# How magnet opening affects PVDIS acceptance

# comment about “Acceptance with 1<sup>st</sup> round proposed opening”

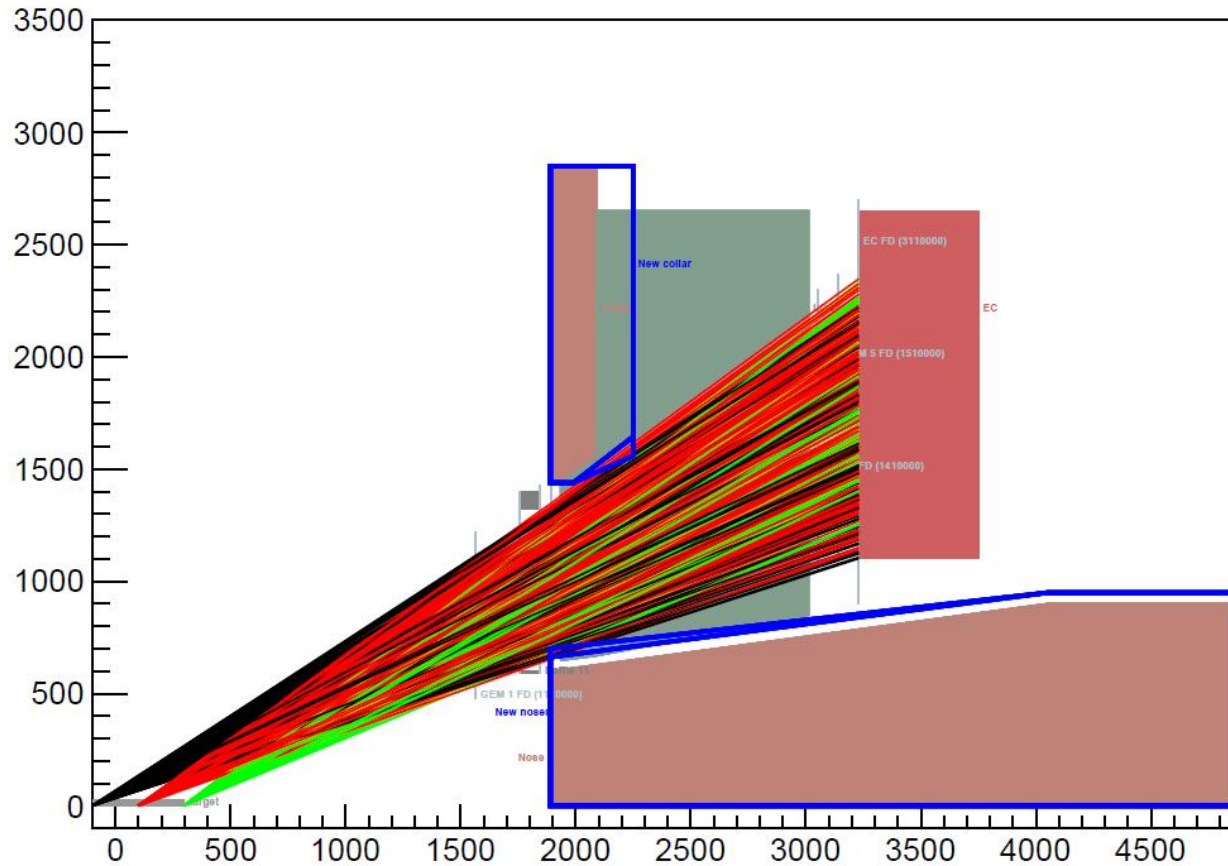
shows DIS tracks for electrons with  $Q^2 > 6$ ,  $W > 2$ ,  $x > 0.55$ , in an  $r$  vs  $z$  view (N.B. not a slice of  $y$  vs  $z$ ) along with some of the PVDIS apparatus.

Old collar and nose (as in MC) are shown as reddish solid shapes. Proposed collars (with small or large exit apertures, 156 or 164.5 cm) and noses (with small or large upstream diameter, 66.25 or 70 cm) are shown as blue outlines.

You can see the tracks are collimated by the baffle (plate 11 is shown) such that there is a several cm margin between these tracks and the old iron keeping them safely away from the magnetic material. Tracks do not intersect the wide aperture proposed collar or the small diameter proposed nose, but there is little or no margin. Tracks do intersect the small aperture proposed collar and the large diameter proposed nose.

If I've done this right we do see tracks right down to the inside edge of the calorimeter.

Given the lack of any margin between the tracks accepted by the baffles and the proposed enlarged iron I think we have to consider our options carefully.
